**Advanced Passive 1000 (AP1000)
Generic Technical Specification Traveler (GTST)**

Title: Changes Related to LCO 3.7.12, Spent Fuel Pool Storage

Section 3.7.12, Spent Fuel Pool Storage

Figure 3.7.12-1 (page 1 of 1)
Minimum Fuel Assembly Burnup Versus Initial Enrichment for Region 2 Spent Fuel Cells

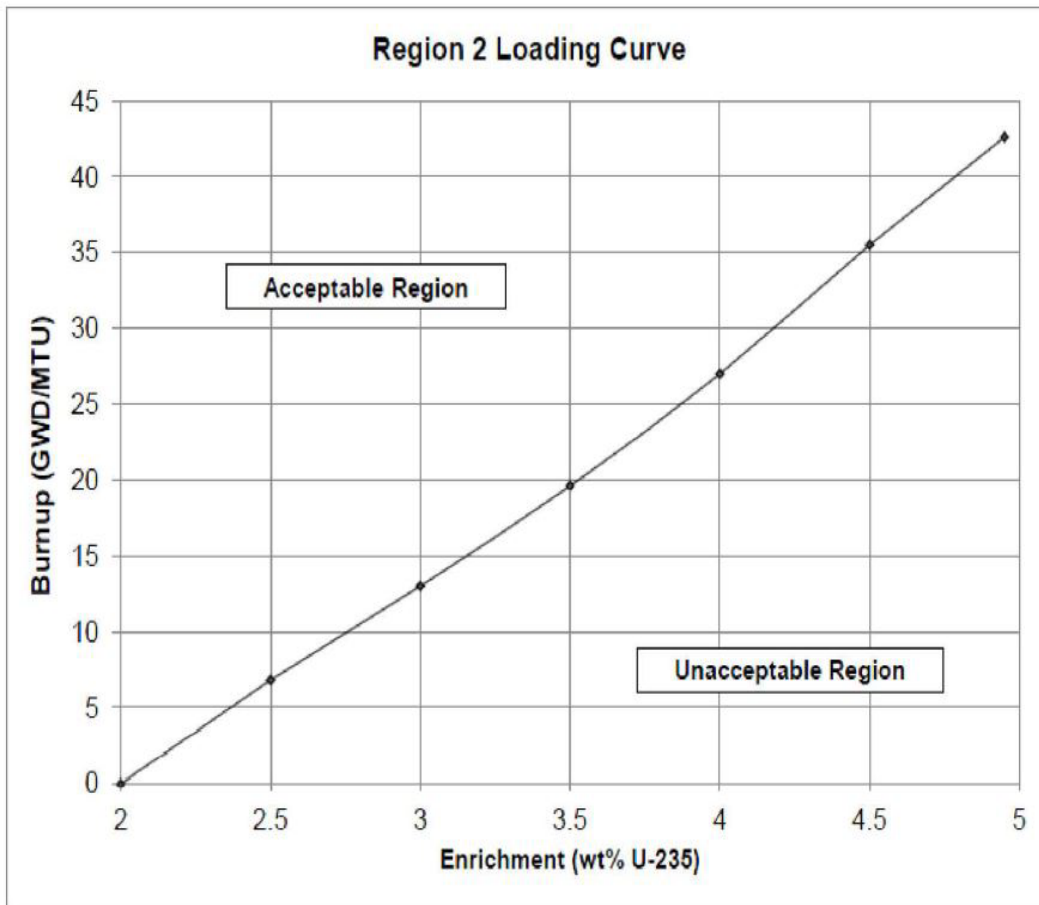
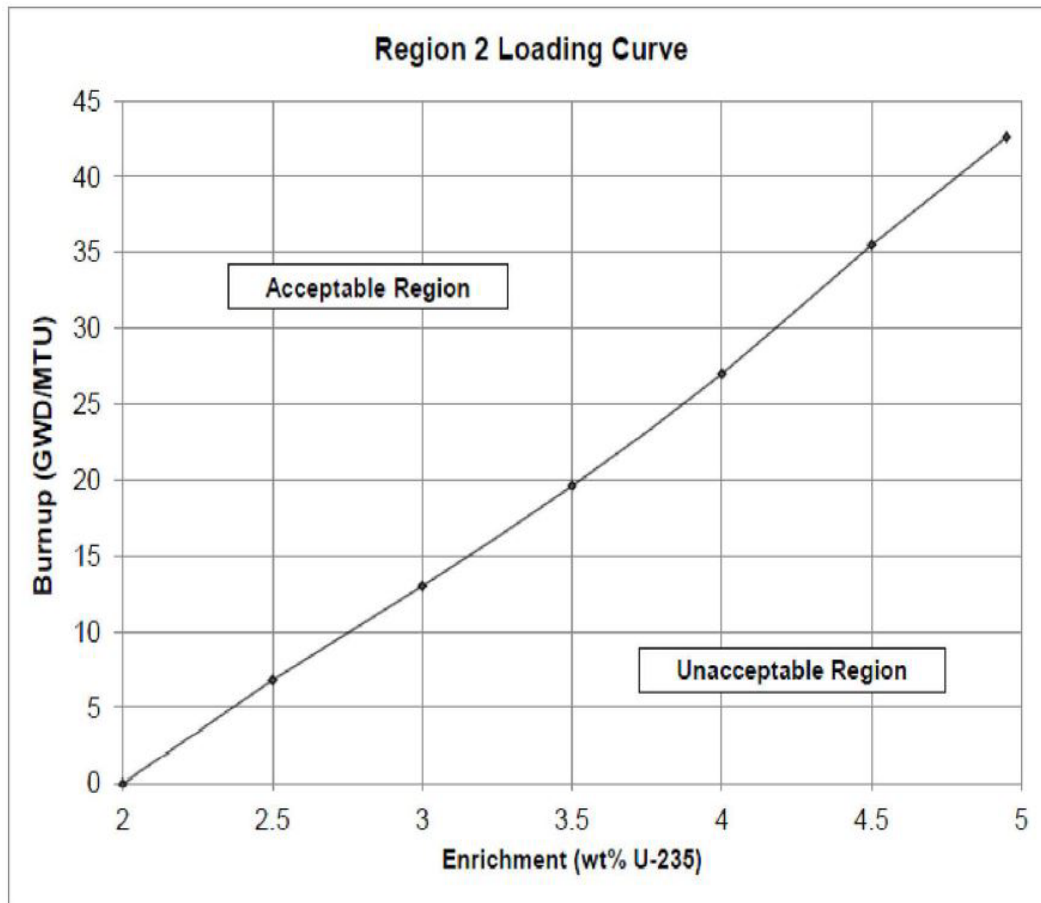
GTS Figure 3.7.12-1 is revised by adding area labels to provide clarity. (DOC A111)

DOC A111 annotates the acceptable and unacceptable regions for loading on Table 3.7.12-1.

DOC A111 provides clarity in interpretation of Table 3.7.12-1.

Region 2 permits storage of spent fuel assemblies in any cell location provided the assembly meets the combination of initial enrichment and burnup shown in LCO Figure 3.7.12-1, Minimum Fuel Assembly Burnup Versus Initial Enrichment for Region 2 Spent Fuel Cells. **The Acceptable Region of the Figure is to the left and above the curve.**
